GEORGE HALL MPR AND SUPPORT ROOMS PROJECT #19-143

ADDENDUM NO. 2

Date: November 19, 2021

Project: #19-143 George Hall MPR and Support Rooms Project
DSA #: 01-119574 41-26

35. SHEET 'FP2.11 – FIRE SPRINKLER PIPING PLAN'

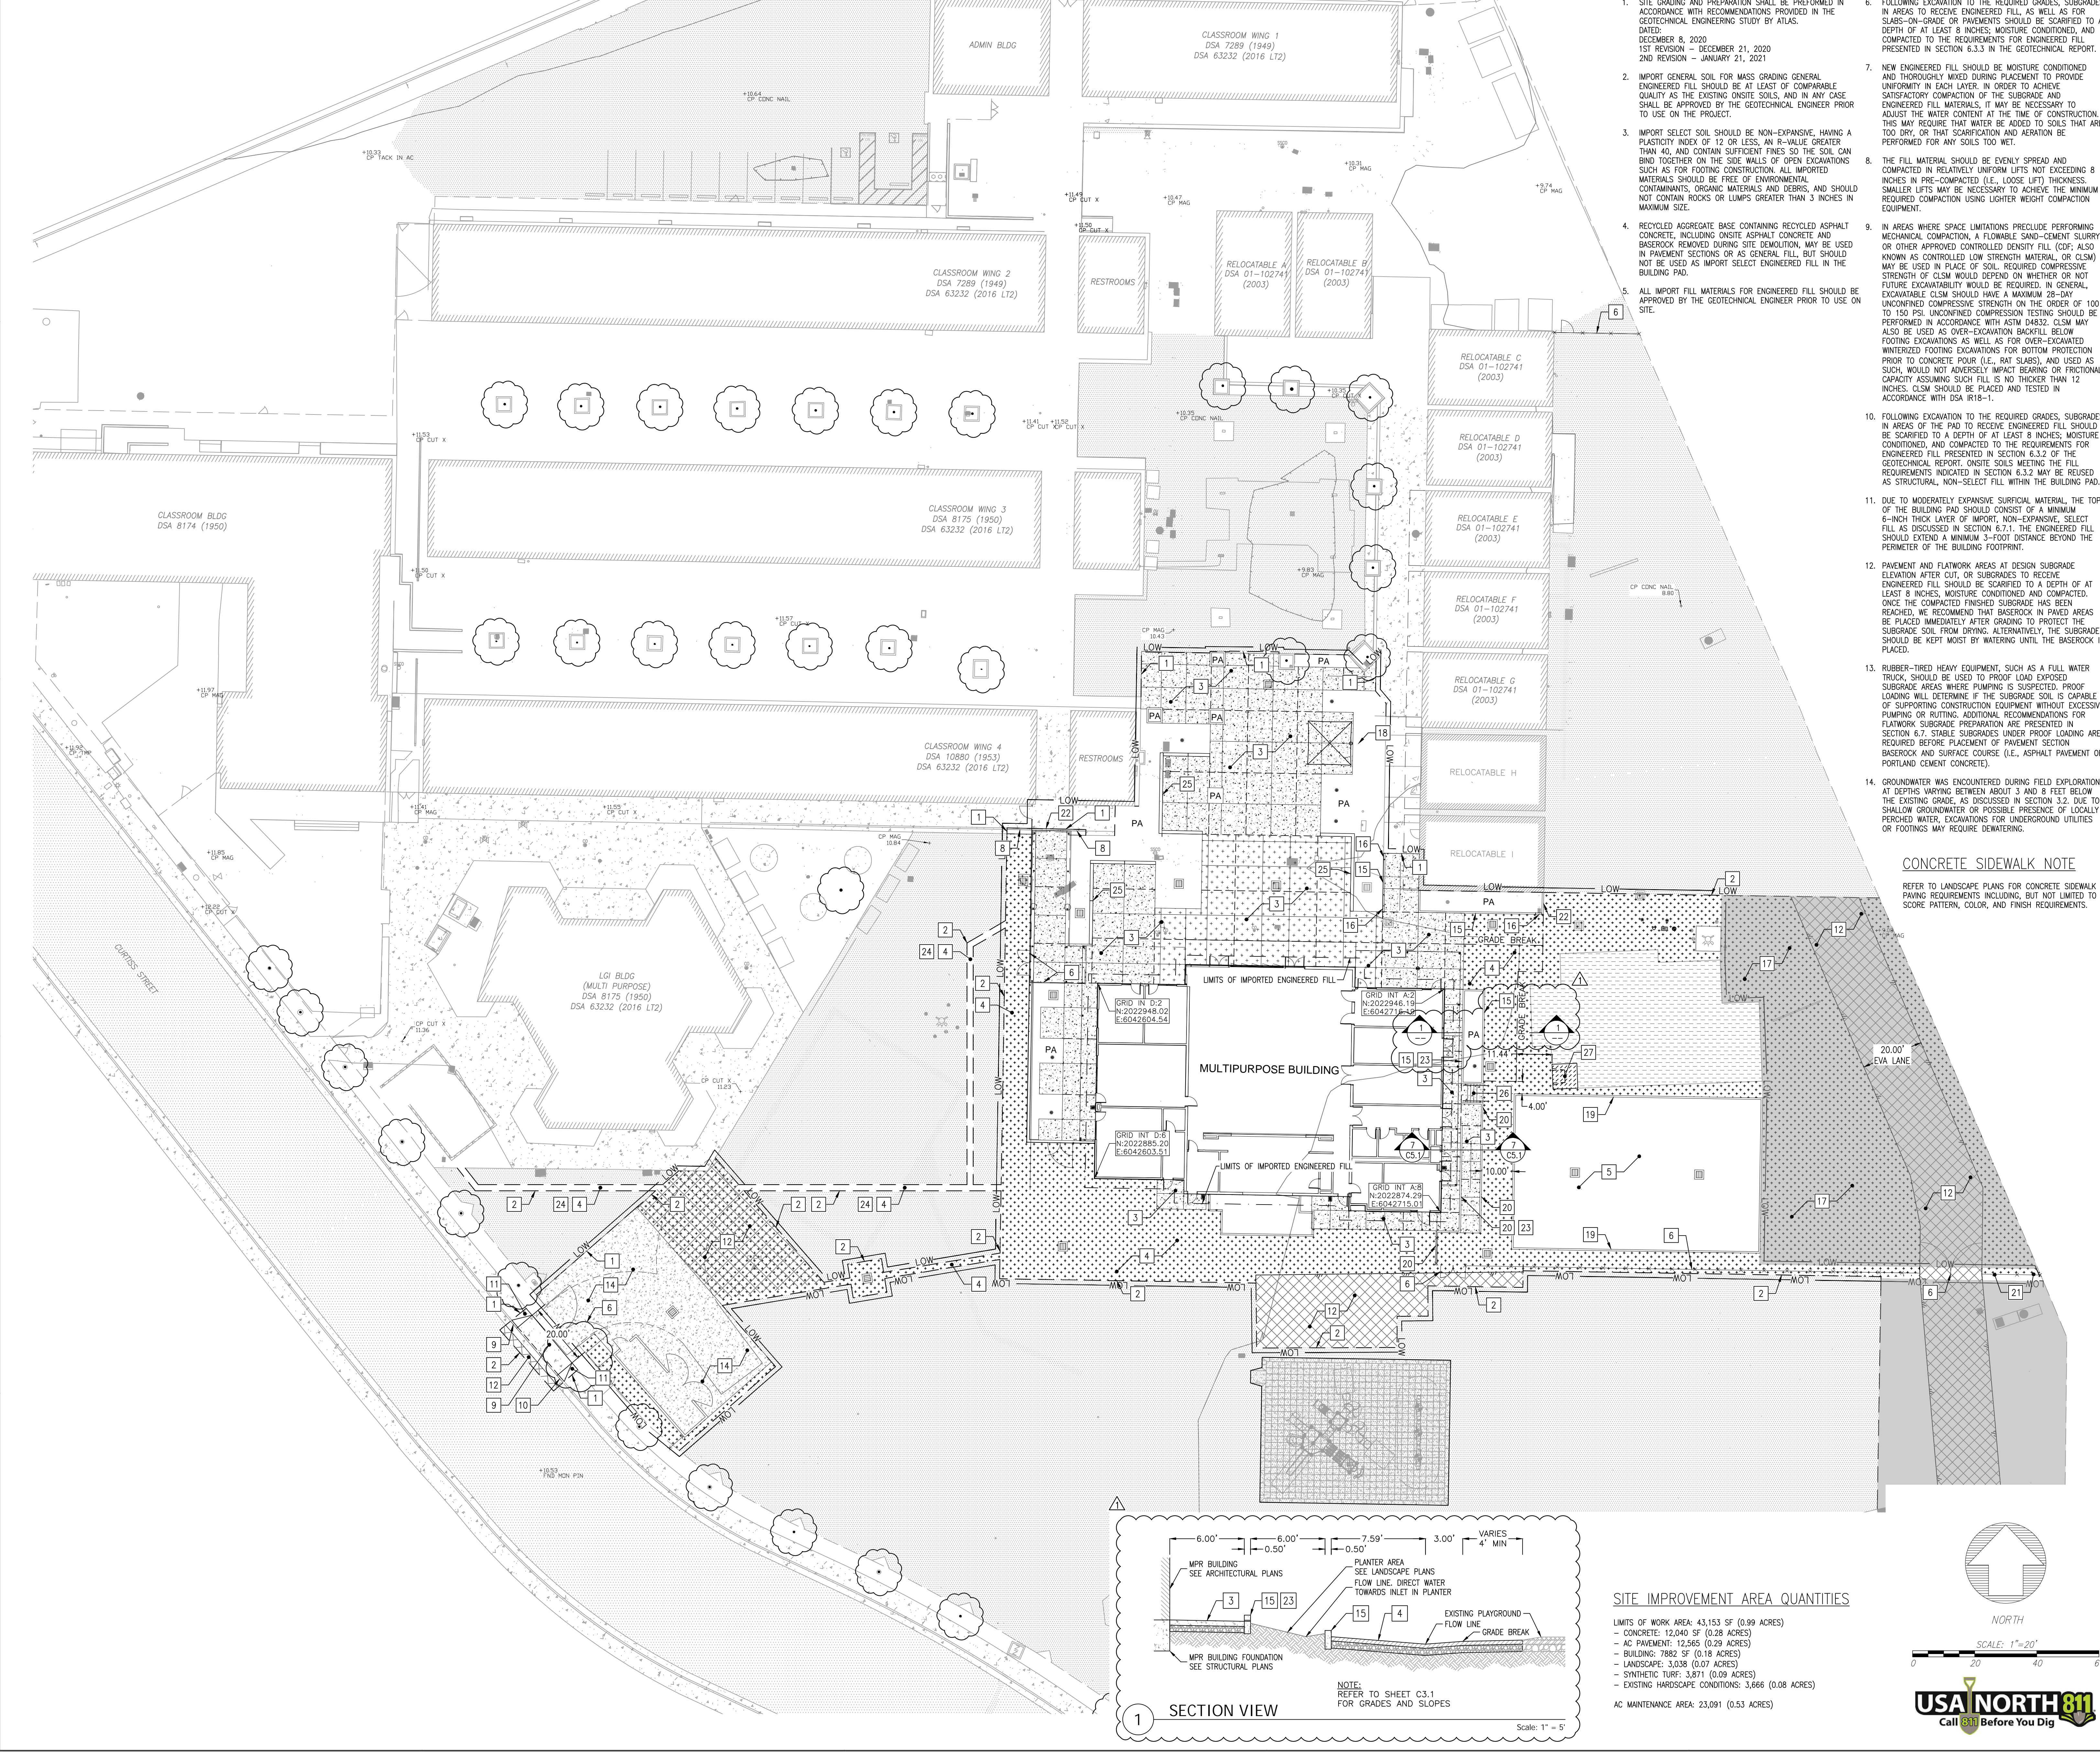
A. Fire Sprinkler piping plan detail 2/- has been updated to align with approach / information shown on 01/G1.1.

GRADING PLAN

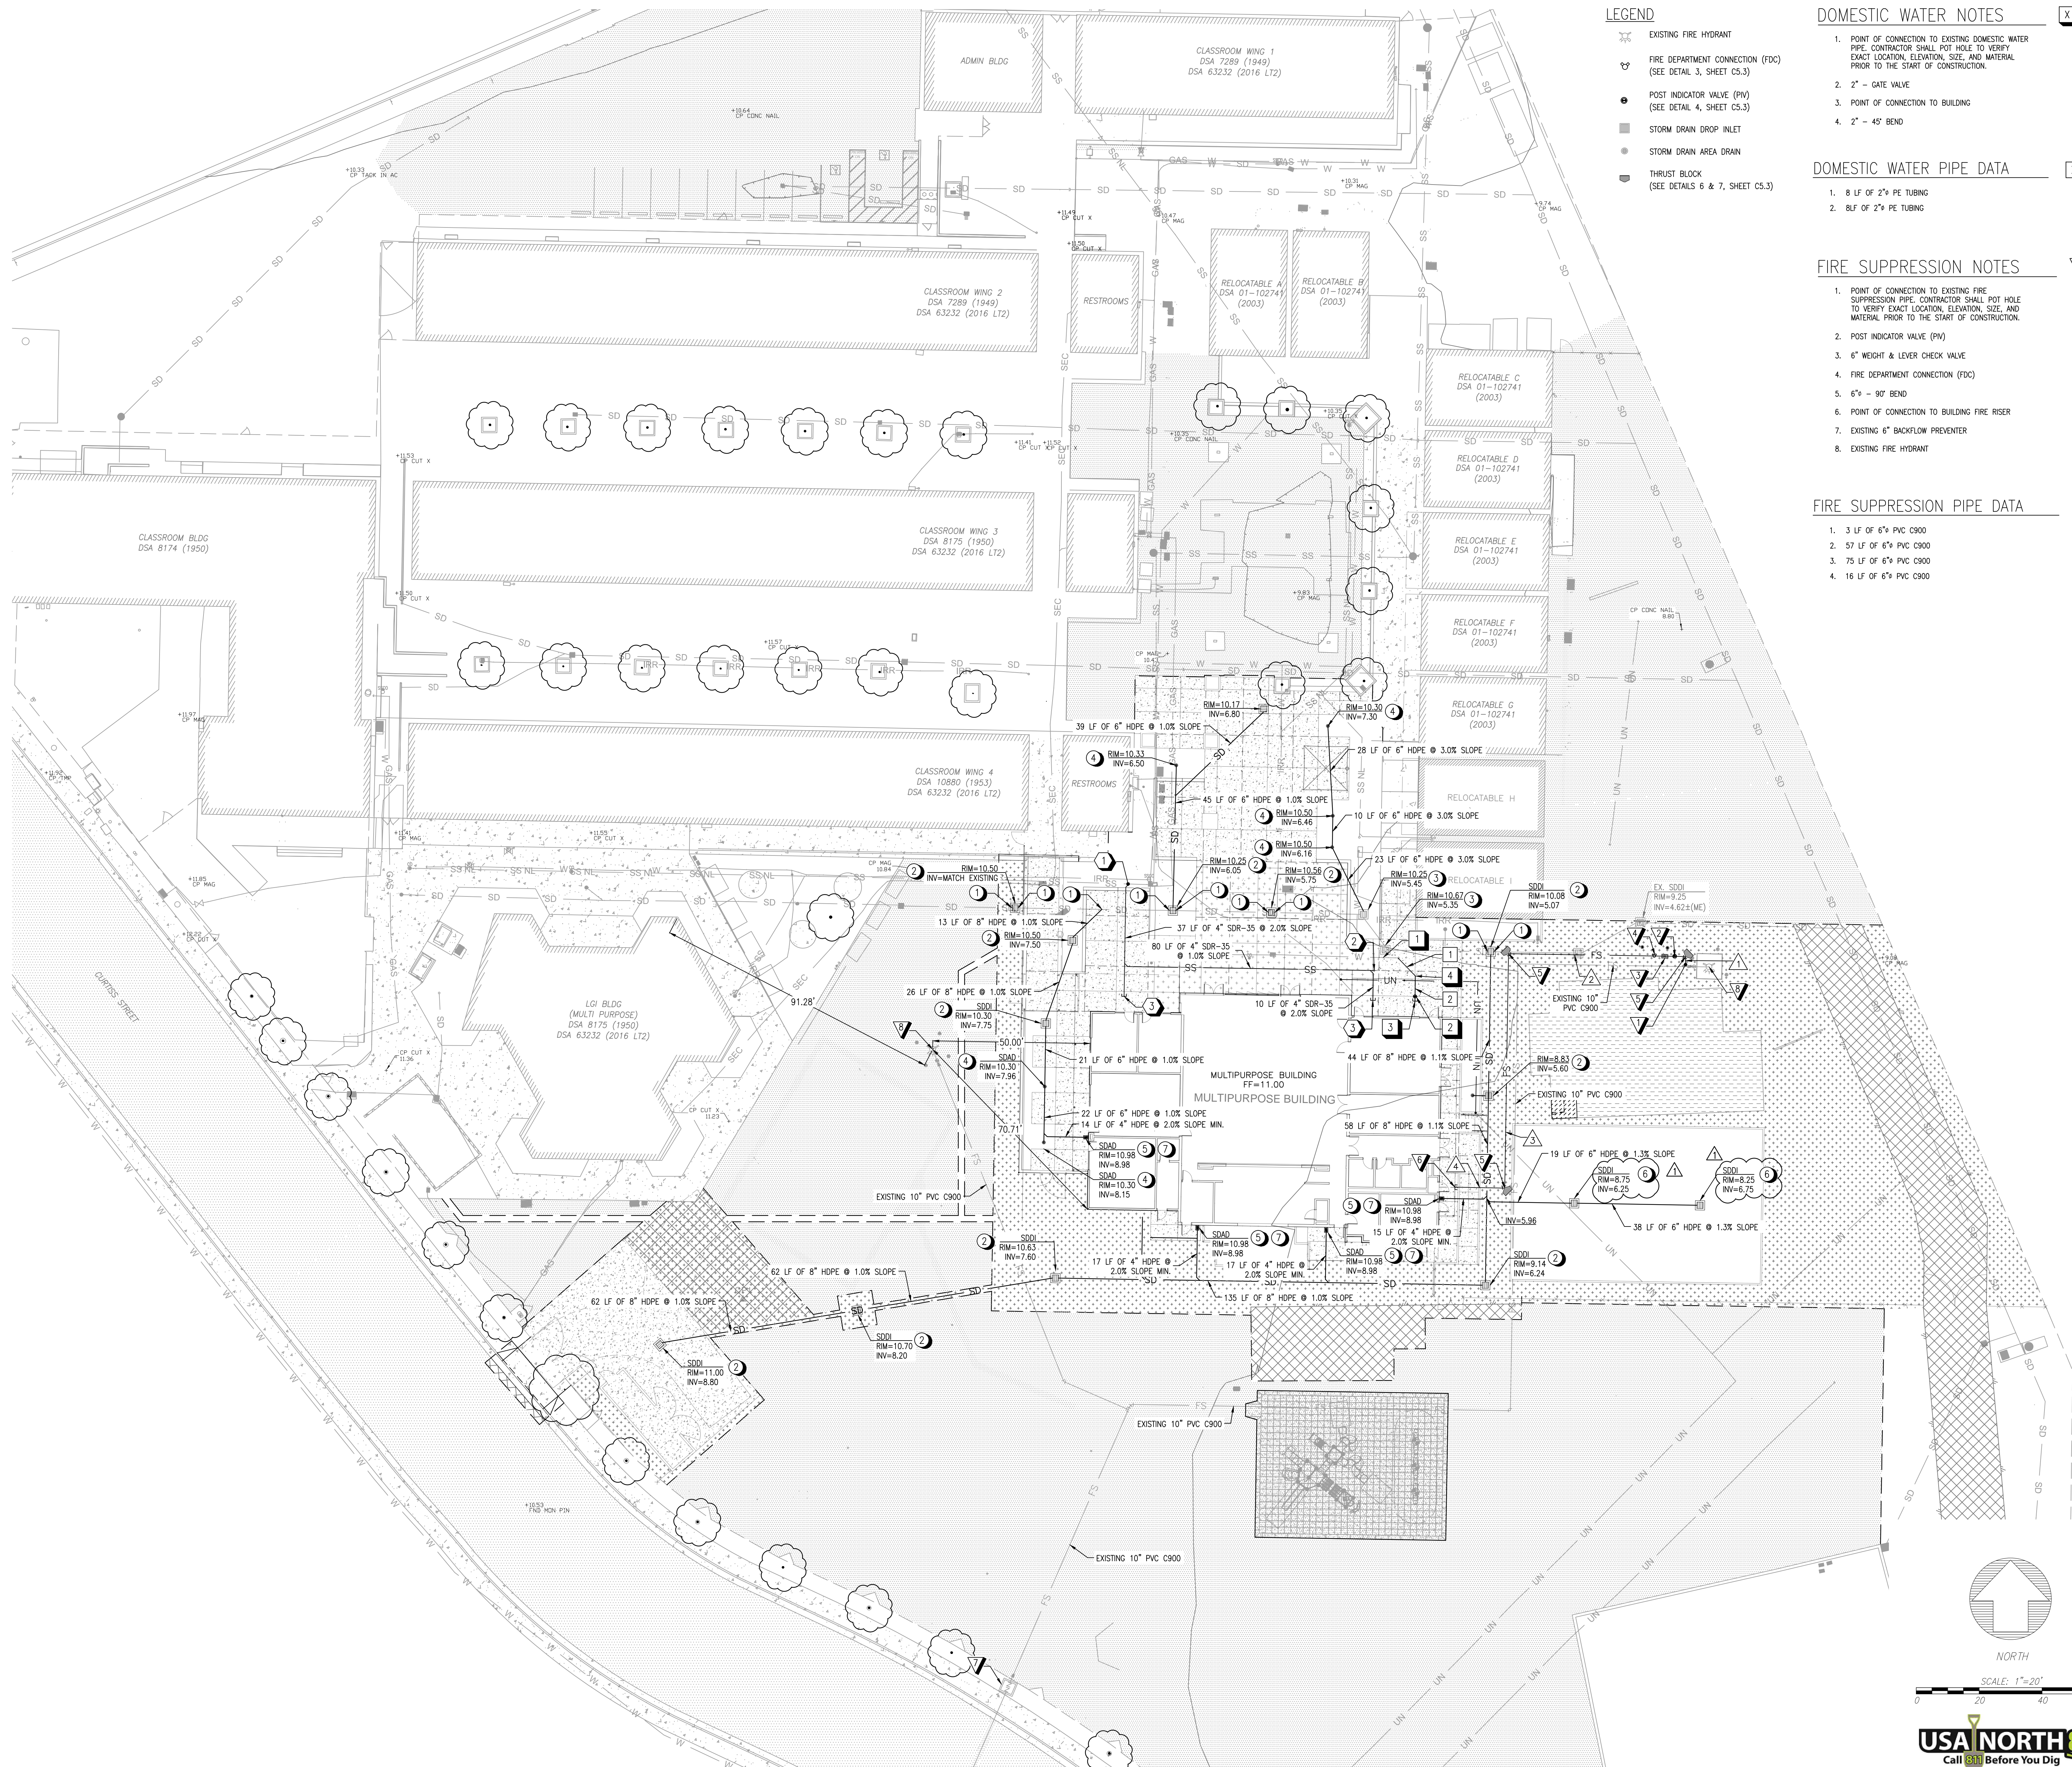
A. Revised several spot elevations, and stair riser heights.
4. SHEET 'C3.1 – UTILITY PLAN'
The following drawing is hereby re issued, with these changes:

SHEET NAME:
UTILITY PLAN

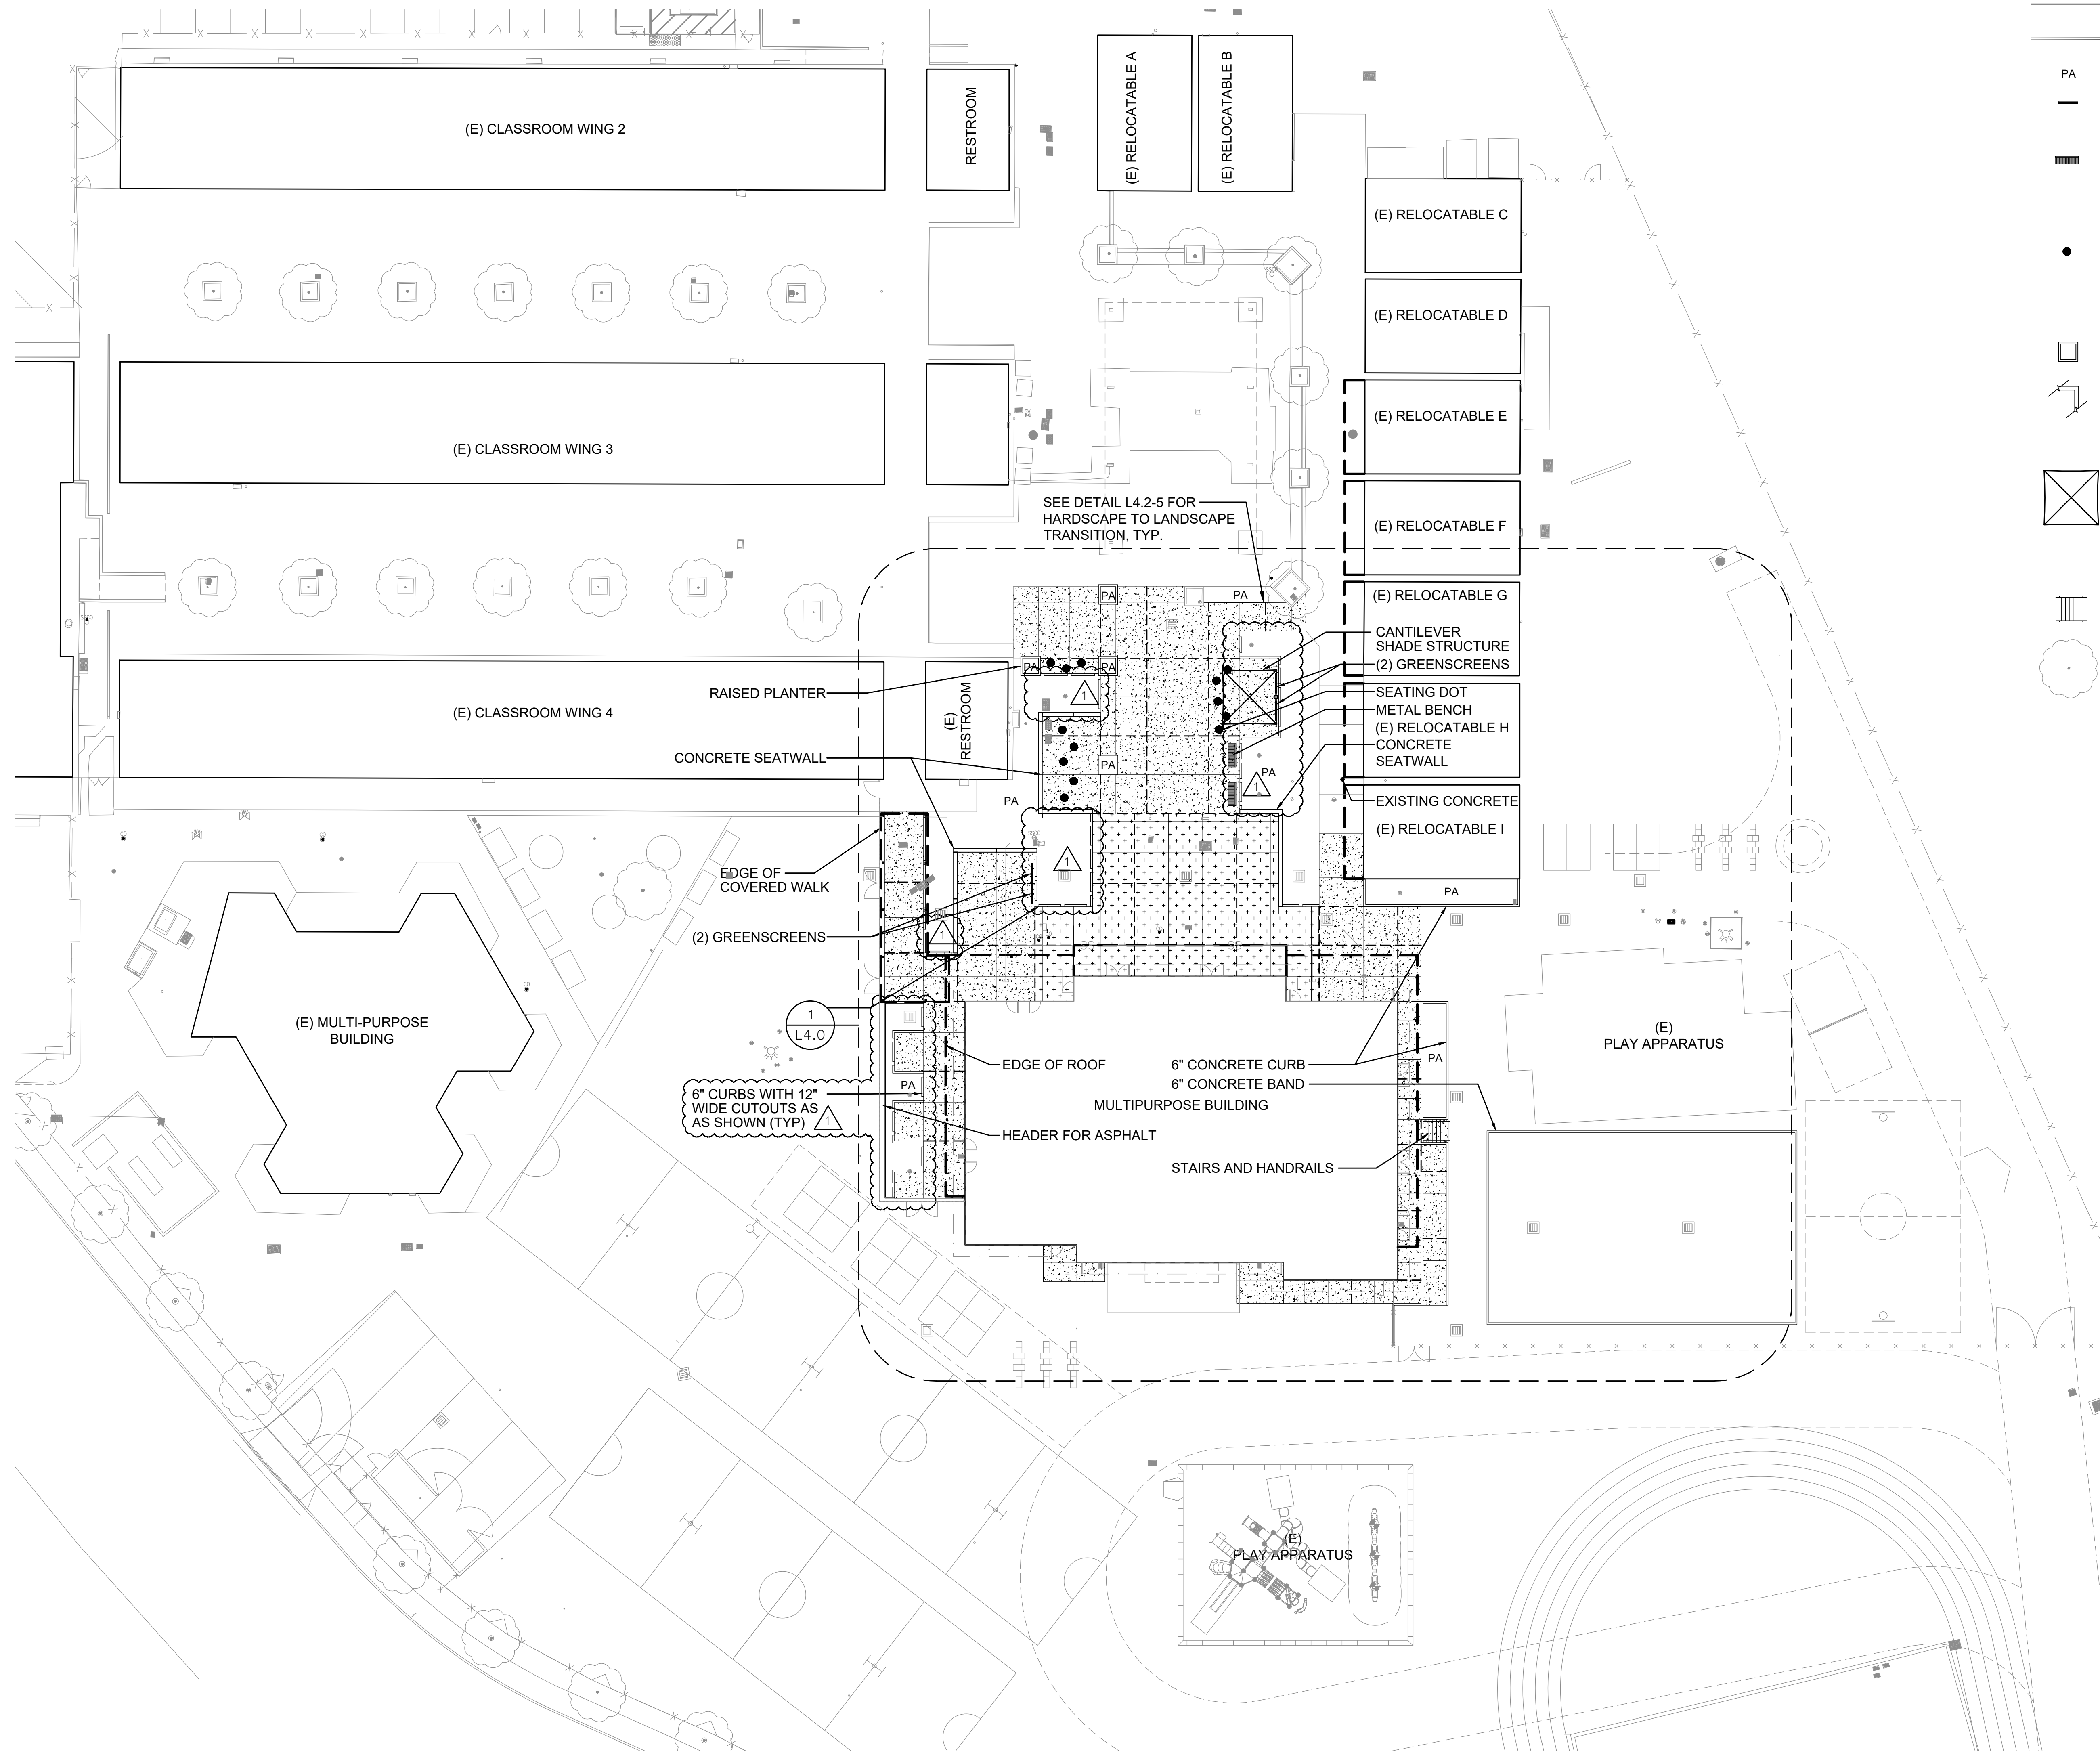
A. Revised drain inlet heights at Turf area.
5. SHEET 'C2.1 – SITE IMPROVEMENT PLAN'
The following drawing is hereby re issued, with this change:
A. Revised paving note on detail 8/C5.1.
